FACILITY: Diablo Canyon Nuclear Power Station, Units 1 and 2 (Diablo Canyon)

SUMMARY OF MEETING HELD ON AUGUST 11, 1976 TO DISCUSS SEISMIC REEVALUATION OF DIABLO CANYON

DIABLO CANYON NUCLEAR POWER PLANT
DOCKET NOS. 50-275, 50-323
STRUCTURAL ENGINEERING BRANCH
DRAFT REQUEST FOR ADDITIONAL INFORMATION

FIG. K - 7% DAMPED SPECTRA, ELASTIC, TAU=0

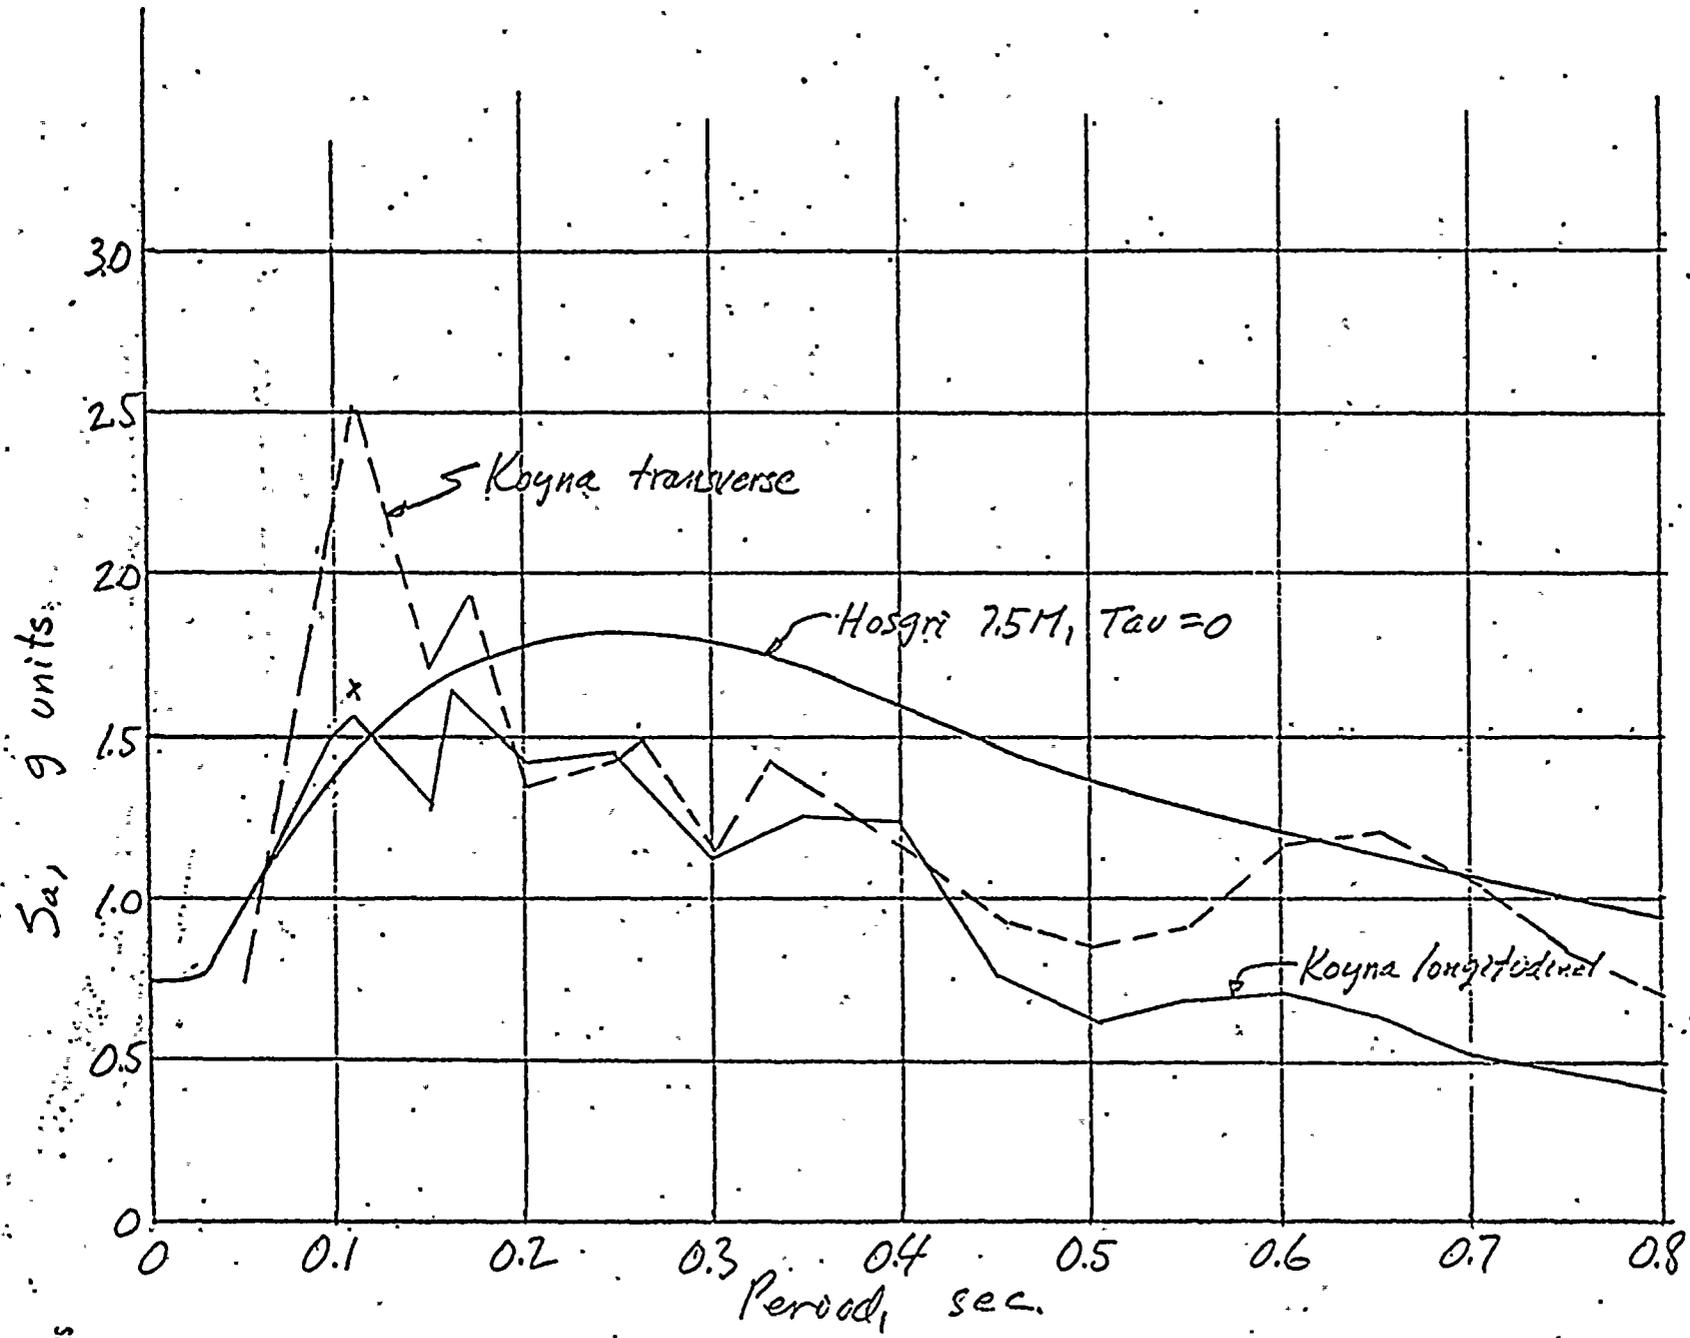
1. Question) Provide justification for not using the original set of 10 earthquakes utilized in developing the Hosgri spectra. What would be the impact of the two omitted earthquakes on proposed response spectra?

Reply) The original set of 10 earthquake records included the 2 components of horizontal motion from the 1967 Koyna Dam Record. Subsequent to the original work it was learned that the Koyna Dam records were not reliable, either due to the effects of the dam or instrumental problems. It was thus decided to eliminate the Koyna Dam records. The impact of omitting these records must be considered academic due to the spurious nature of the Koyna records, however, it will be shown in a later figure if needed.

Figure K shows 7% damped spectra for elastic conditions, free field ($\tau = 0$). The Hosgri curve is shown together with the two Koyna curves. The Hosgri curve is above the Koyna longitudinal curve for almost the entire spectral range and it is above both Koyna curves for most of the spectral range. The greatest divergence is at 0.11 sec period. However, the Hosgri curve has a weight of 8 (8 records) while the Koyna has 2 (2 records). Taking a weighted average at the worst period, 0.11 sec, the result is about 1.6 g which is shown by the cross in the figure. The Koyna records would have little effect on the average curve if they were used. However, the transverse Koyna peak is no doubt a result of dam response and should not be used.

FIG. N - COMPARISON OF SPECTRAL CURVES, $\tau = 0.08$, Dp 7%

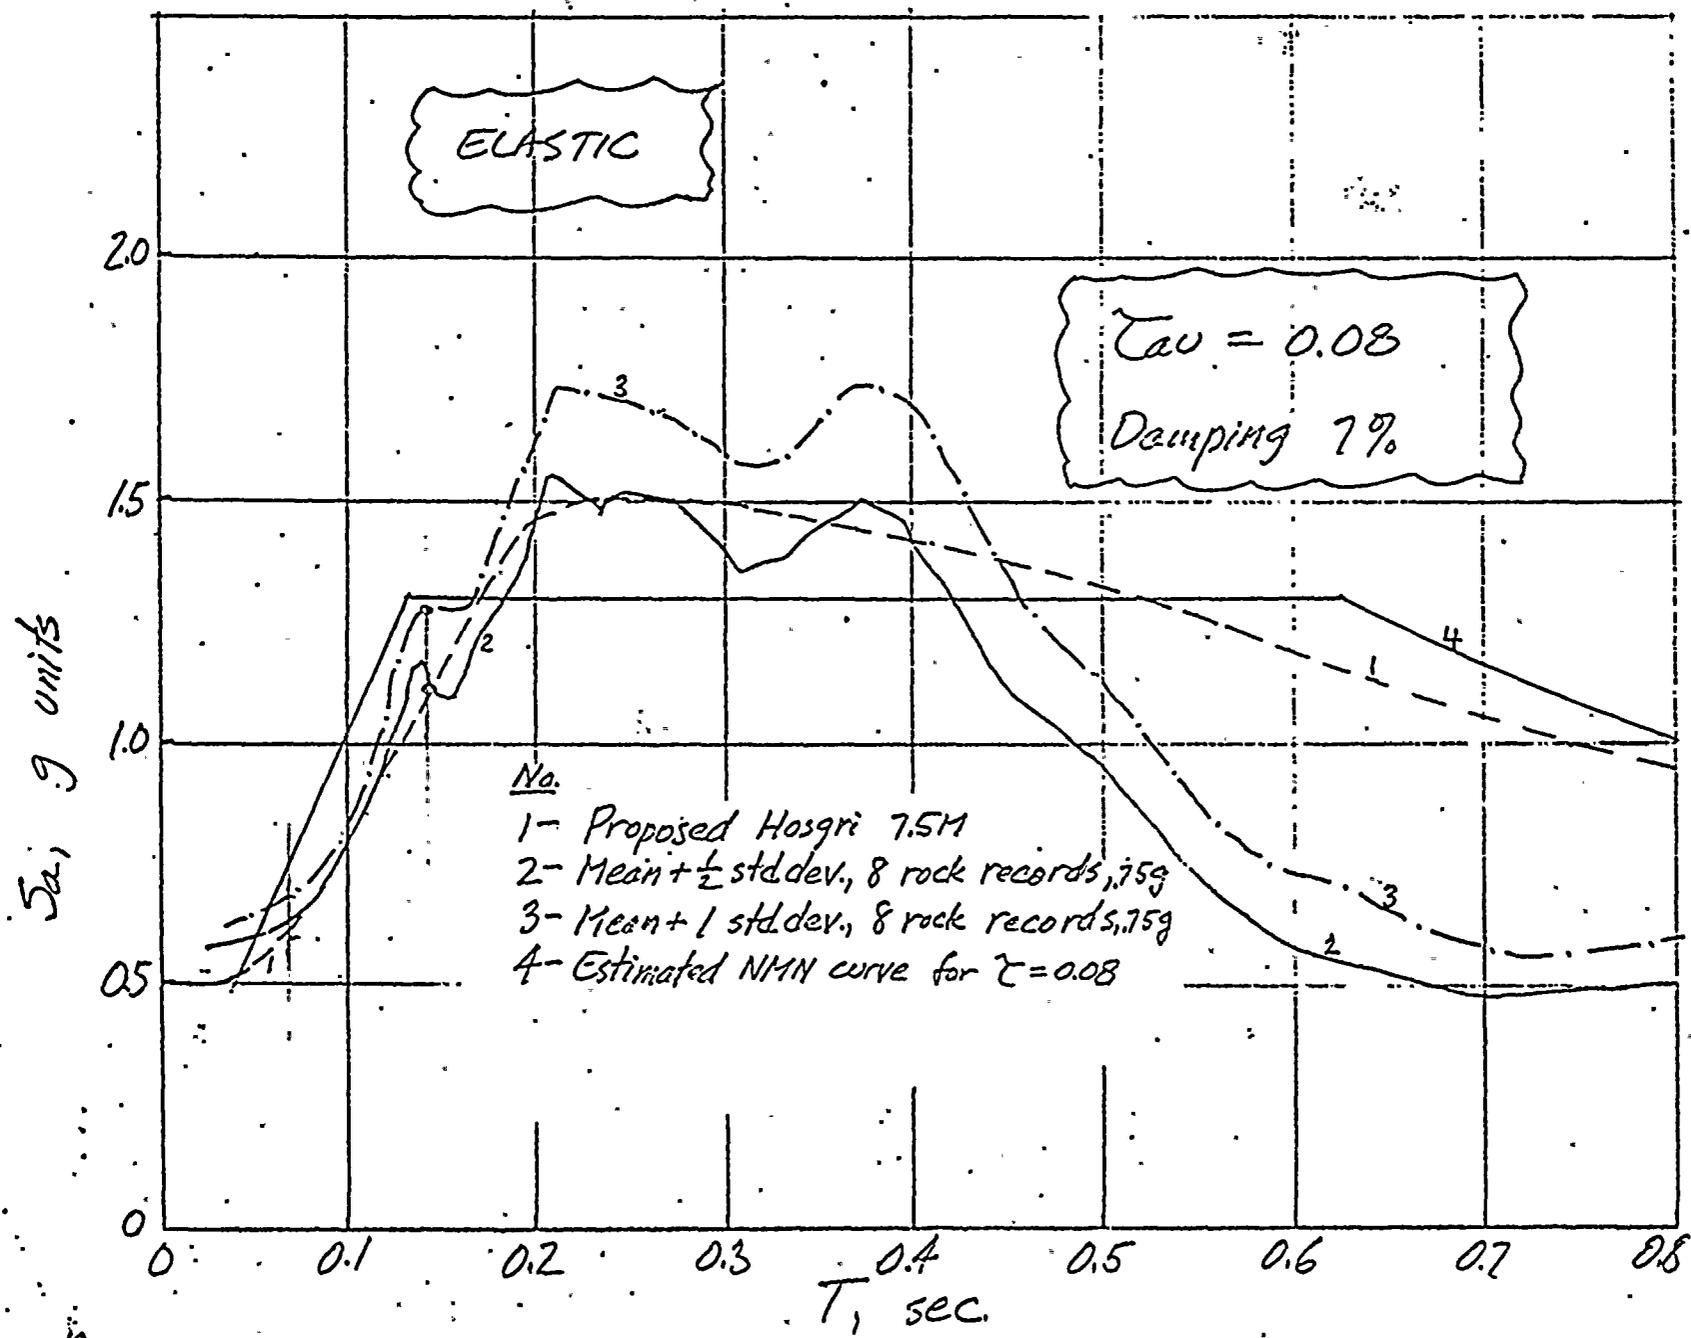
2. Question) Provide justification for the magnitude of the adjustment made to the response spectrum above 0.4 sec. for the higher magnitude earthquake. Provide graph showing the spectra shape as derived from the strong motion records cited on page 2 and the adjustment for long periods for the higher magnitude earthquake.

3. Question) (a) Provide the mean, median and the standard deviations of the spectral response. It is not clear whether mean + standard deviation (σ) or mean + $1/2\sigma$ was used in developing the final spectra. Provide justification if mean + $1/2\sigma$ was used.

Reply) Figure N shows the spectral diagrams for $\tau = 0.08$, 7% damping, elastic conditions. Curves 2 and 3 provide the spectral response data from the 8 close-in rocky site records for the mean plus one-half standard deviation and the mean plus one standard deviation, respectively. Curve 1 in Figure N is the proposed Hosgri curve and it is considerably greater than curves 1 and 2 beyond 0.5 sec period. This increase is to provide for magnitude scaling effects.

The 8 close-in records were treated as follows for a study of magnitude scaling. Each record was normalized to 0.1g and then each pair of horizontal components for each station was averaged and the pseudo spectral response velocity was computed for 7% damping and the various periods of the spectrum. Figure V, attached, shows the spectral velocity plotted versus magnitude for several periods ranging from 0.6 secs to 2 secs. Also shown on the plot are the points at 7.5M taken from the Hosgri curve, converted to spectral velocity and normalized to 0.1g. It can be seen that the points taken from the curve represent a reasonable extrapolation of the results from the four earthquakes having magnitudes of 5.3, 5.6, 6.0, and 6.5.

Reply) (a) Figure N shows curve 2 for the mean plus one-half standard deviation for the 8 close-in rock records normalized to 0.75g and adjusted for Tau equal to 0.08. All curves on the sheet are elastic, and for 7% of critical damping. Curve 3 is the same except it is for the mean plus one standard deviation. The value of one standard deviation at any period is twice the difference between curves 2 and 3.

Curve 1 is the proposed spectral curve for the analysis to resist a 7.5M Hosgri zone earthquake. It can be seen that this smooth curve averages slightly greater than curve 2 except in the extreme high frequency range where it is less (with some allowance for embedment values not otherwise considered) and beyond 0.4 sec period where allowances have been made for magnitude effects.

FIG. M-79 DAMPED SPECTRA, ELASTIC, $\tau = 0$

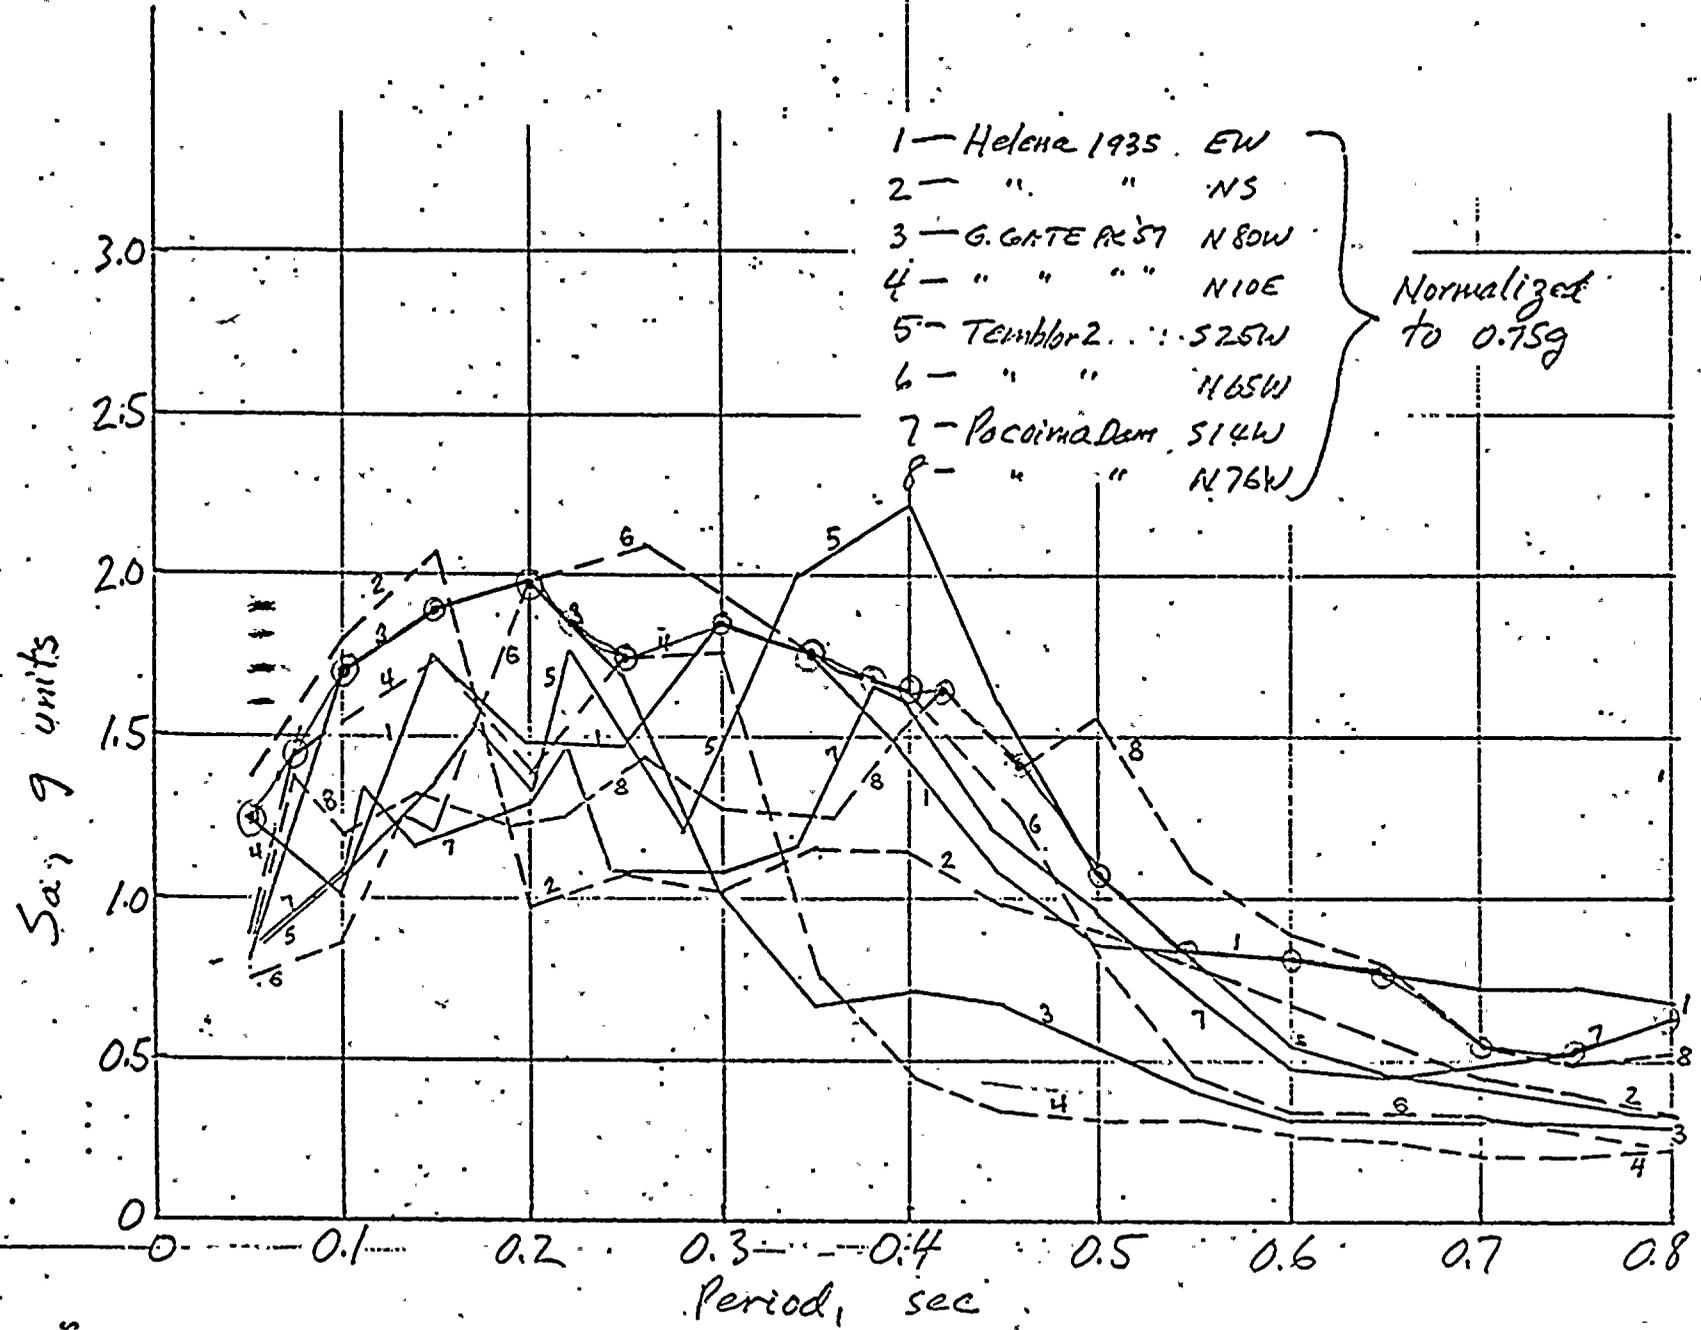
(b) Provide figures illustrating the spectra for the earthquakes on page 2 all on the same graph scaled to the .75g high frequency asymptote.

Reply) (b) Figure M, attached, provides the requested plot of the 8 spectral diagrams, each normalized to 0.75g and each for 7% of critical damping. These are elastic curves, with no adjustment for Tau effects.

EXTERIOR CONTAINMENT STRUCTURE TORSIONAL MOTION

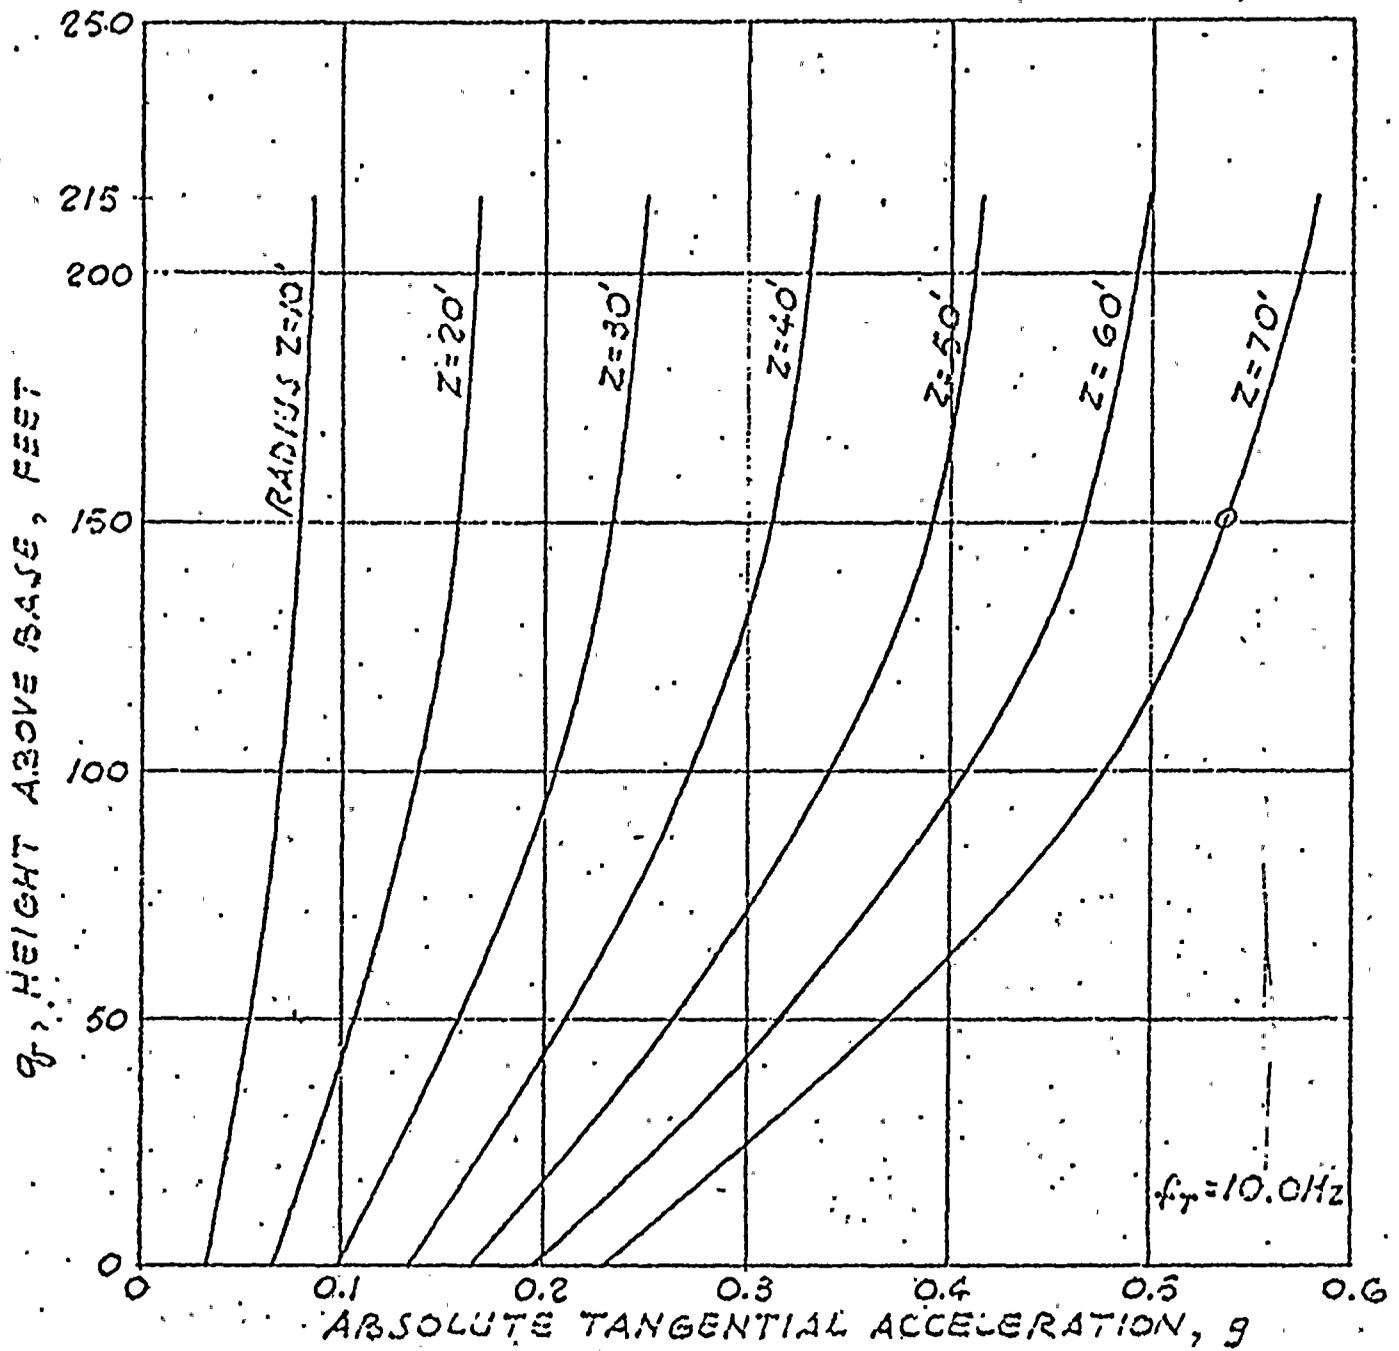
6. Question) Provide justification for the statement that "torsion represents a relatively small contribution to the total seismic load".

15. Question) Provide detailed explanation of Fig. 14 regarding containment structure torsional motion and its use in analysis.

Reply) Figures T1, T2, and T3, attached, show absolute tangential acceleration for various heights and radial distances in the Exterior Containment Structure, the Interior Containment Structure, and the Auxiliary Structure, respectively. These plots are based on the submitted Appendix 3.7A and the supplementary data provided under Question No. 15. The circles in these plots represent cases of q and z (height, q, above base and radius, z) that will be considered herein as extreme situations. Most qz pairs will be much less critical.

Reply) The tangential acceleration applied to the foundation causes torsional twist of the superstructure and amplification due to inertial effects. The torsional acceleration increases with height above the base and with the radius from the center of rotation. It is zero at the center of rotation at any height in the structure. The following formula was derived under the assumption that the torque varies from T_0 at the base to zero at the top.
